To: T10 Technical Committee
From: Bob Sheffield (Robert.L.Sheffield@Intel.com), Intel Corporation
Date: November 4, 2002
Subject: T10/02-435r2, SAS STP Buffering

Overview

Figure 79 HOLD/HOLDA latency through an expander device

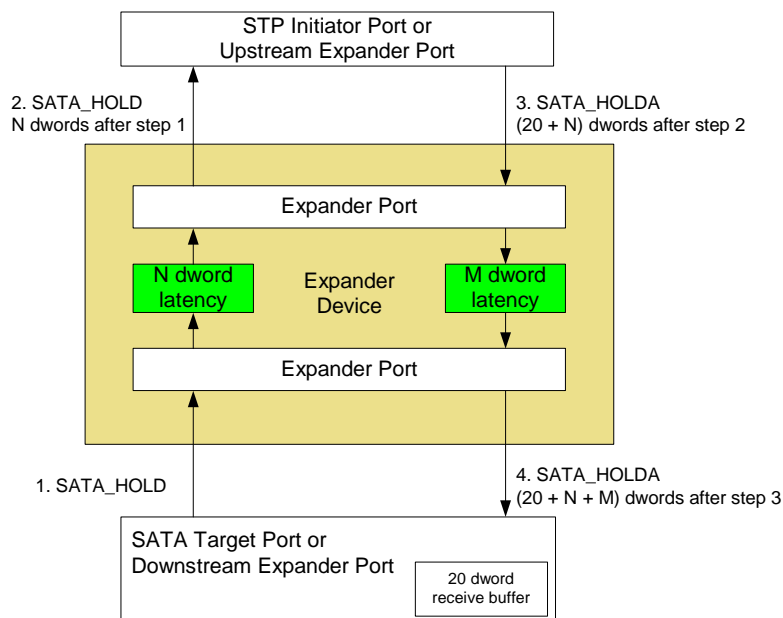
Figure 79 shows how an expander device that does not implement its own SATA_HOLD/SATA_HOLD_A handshake with a SATA target port may cause the 20 dword receive buffer in the SATA target device to overflow on transfers to the SATA target device. Outbound data continues to stream through the expander device to the SATA target device while the expander device propagates the SATA_HOLD upstream, during the time the SATA initiator port takes to turnaround the SATA_HOLD_A response, and the SATA_HOLD_A to make the return trip to the SATA target device. The dwords transmitted during the added latency above and beyond that allocated for the SATA_HOLD_A turnaround time

at the STP initiator port may overflow the 20-dword buffer in the SATA target device.

To solve this problem, each expander device shall generate its own SATA_HOLD in response to a SATA_HOLD primitive received from a downstream phy along the STP connection pathway, and shall propagate the SATA_HOLD primitive to the next upstream phy along the STP connection pathway. After transmitting the SATA_HOLD to the downstream phy, the expander device shall be capable of accepting at least 20 more dwords of data from the upstream phy before the upstream suspends the transfer and replies with SATA_HOLD. If the expander introduces latency between the transmission of SATA_HOLD to the downstream phy and forwarding SATA_HOLD to the upstream device, the expander shall be capable of buffering the number of additional dwords (beyond the 20 dwords for SATA_HOLD turnaround) transferred during this delay.

Figure xx – Expander device buffering & HOLD/HOLDA handshake (transfer in)

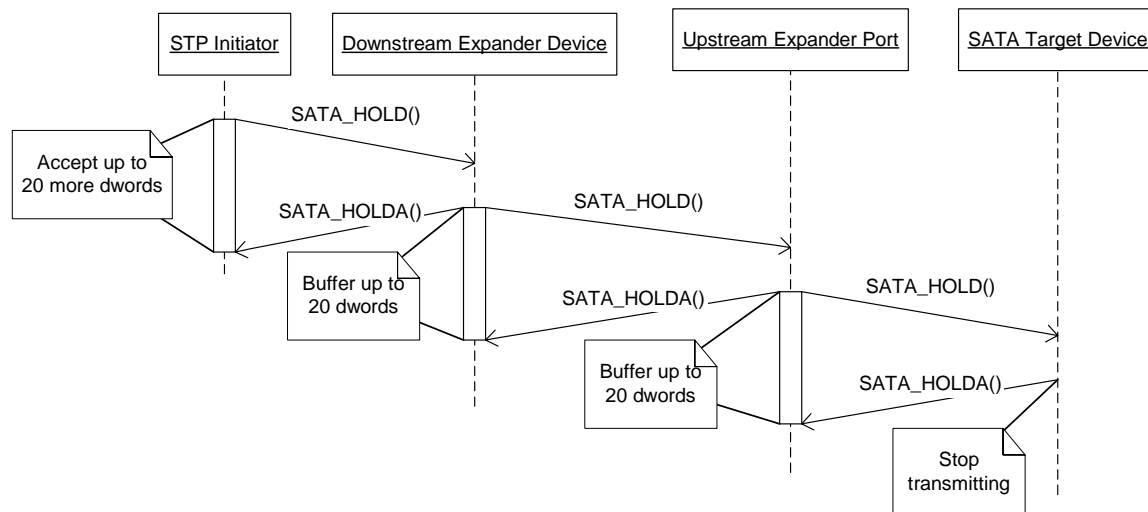
Figure xx shows the propagation of the SATA_HOLD primitive upstream through the pathway of an STP connection, the SATA_HOLD reply of each expander along the pathway, and the interval during which each expander must buffer incoming dwords. In this case the time to propagate the SATA_HOLD primitive to the next upstream phy is hidden behind the processing time to turnaround SATA_HOLD to the downstream phy, so the expander need only buffer up to 20 dwords to account for the SATA_HOLD turnaround time of the next upstream phy.

Figure xx – Expander device buffering & HOLD/HOLDA handshake (transfer out)

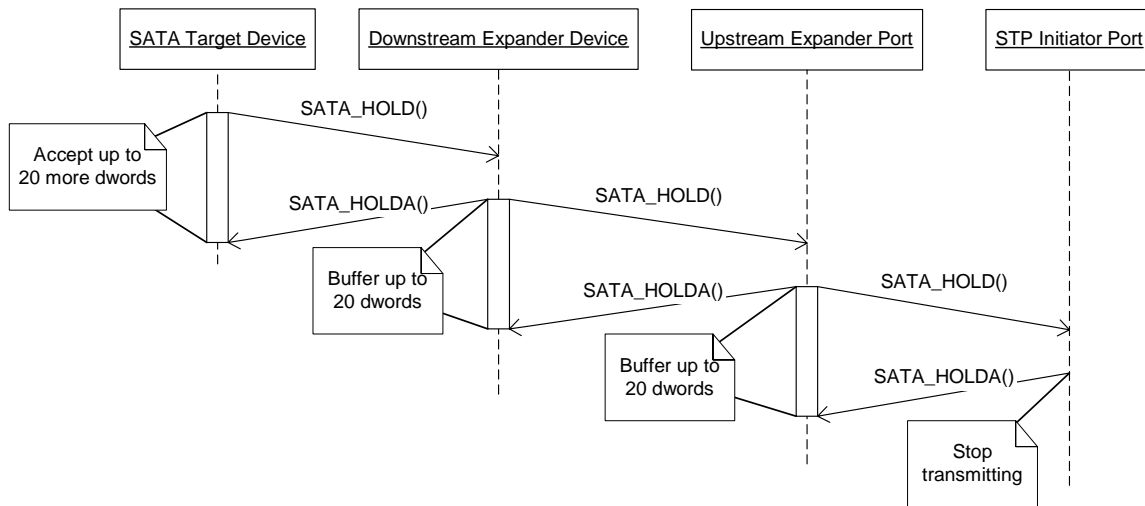
Figure xx shows the SATA_HOLD/SATA_HOLDDA handshake and dword buffering for two stages of expander devices along the pathway of an STP connection transferring data from a SATA initiator port to a SATA target device. The flow-control protocol is completely symmetrical as compared to the transfer-in shown in the previous diagram.

Figure xx - Continuing a transfer following SATA_HOLD/SATA_HOLD_A

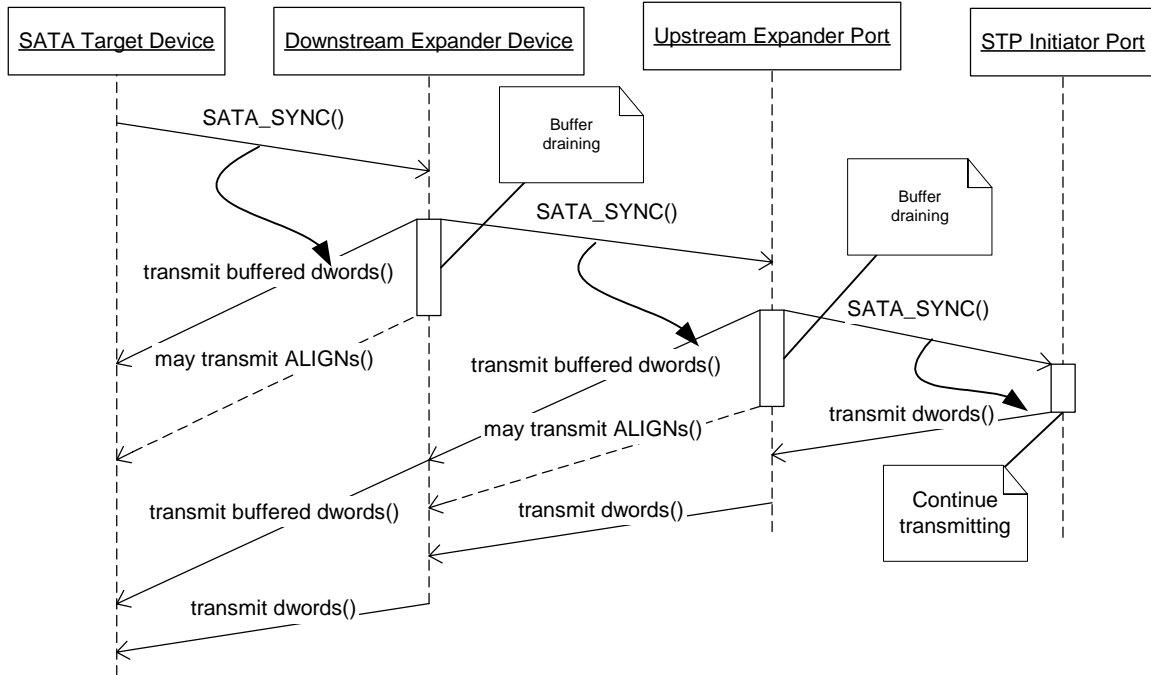
Figure xx shows the continuation of a transfer previously suspended via SATA_HOLD. Initially the upstream path shall be a continuous stream of SATA_HOLD_A transmissions across every link from the SATA target device to the STP initiator port, and the downstream path shall be a continuous stream of SATA_HOLD transmissions across every link of the pathway from the STP initiator port to the SATA target device. When the SATA target device is again ready to accept data, it shall quit transmitting SATA_HOLD and shall transmit something else (such as SATA_SYNC). Each expander device shall continue to transmit SATA_HOLD to the upstream phy and SATA_HOLD_A to the downstream phy until it receives something other than SATA_HOLD from the upstream phy. Upon receiving something other than SATA_HOLD from the upstream phy, an expander device shall begin transmitting data from its internal buffer to the downstream phy and shall forward the received dwords towards the upstream phy. If the expander device buffer becomes empty before receiving data from the upstream phy, the expander device shall fill the downstream dword stream with ALIGNs until it receives data from the upstream phy to forward to the downstream phy.
